# **FIRE SAFETY INSPECTION REPORT**

**P.M KNITTEX (PVT) LTD**  
**CHOWDHURI BARI, GODHNAIL, NARAYANGONJ**

**ACCORD**  
on Fire and Building Safety in Bangladesh

May 22, 2014

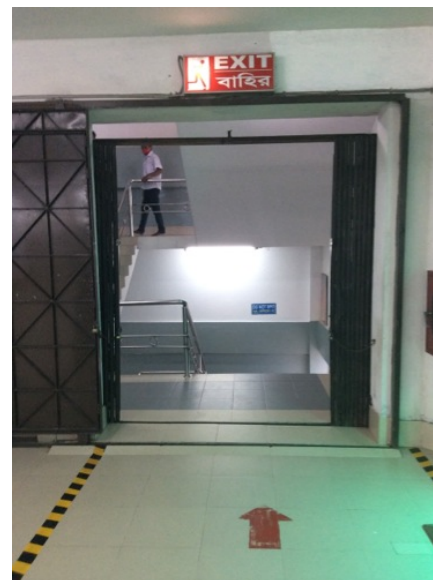
| No.                                                                                                                                                                                                                                       | Category                | Finding                                                                                                                                             | Recommendation                                                                                                                                                                                                                                                                  | Remediation Timeframe |
|-------------------------------------------------------------------------------------------------------------------------------------------------------------------------------------------------------------------------------------------|-------------------------|-----------------------------------------------------------------------------------------------------------------------------------------------------|---------------------------------------------------------------------------------------------------------------------------------------------------------------------------------------------------------------------------------------------------------------------------------|-----------------------|
| F-2                                                                                                                                                                                                                                       | Fire Rated Construction | Areas used for combustible storage are not separated by fire-rated construction on the 1st and 3rd floor.                                           | <p>Provide dedicated storage rooms separated by minimum 1-hr fire-rated construction.</p> <p>Where separate storage rooms are not feasible, provide defined storage areas and limit the storage arrangement as follows:<br/>Maximum height of 2.4m and maximum area of 23m2</p> | Within 3 months       |

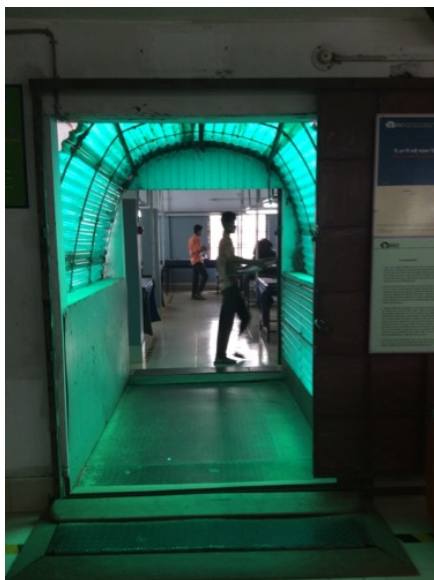
| F-5 | Fire Rated Construction | Building 01 and Building 02 are connected to each other with sky bridge on the 2nd and 3rd floors. | Separate buildings with fire-rated construction. | Within 3 months |

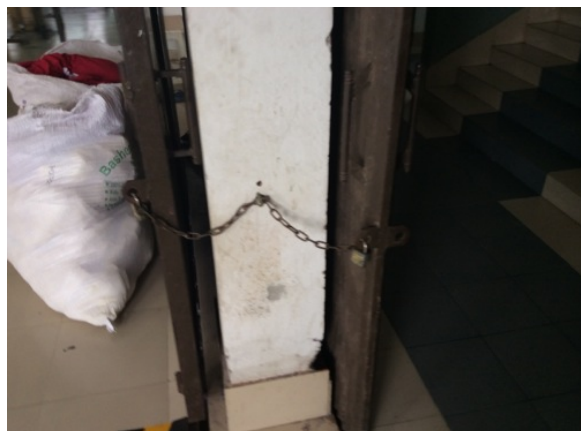
| F-9 | Egress | Sliding doors are provided at exit stairs on every floor. | Replace all sliding doors along the means of egress with side-hinged, swinging egress doors.<br><br>If locks are required for security reasons, utilize special door locking features complying with NFPA 101. | Within 1 month |
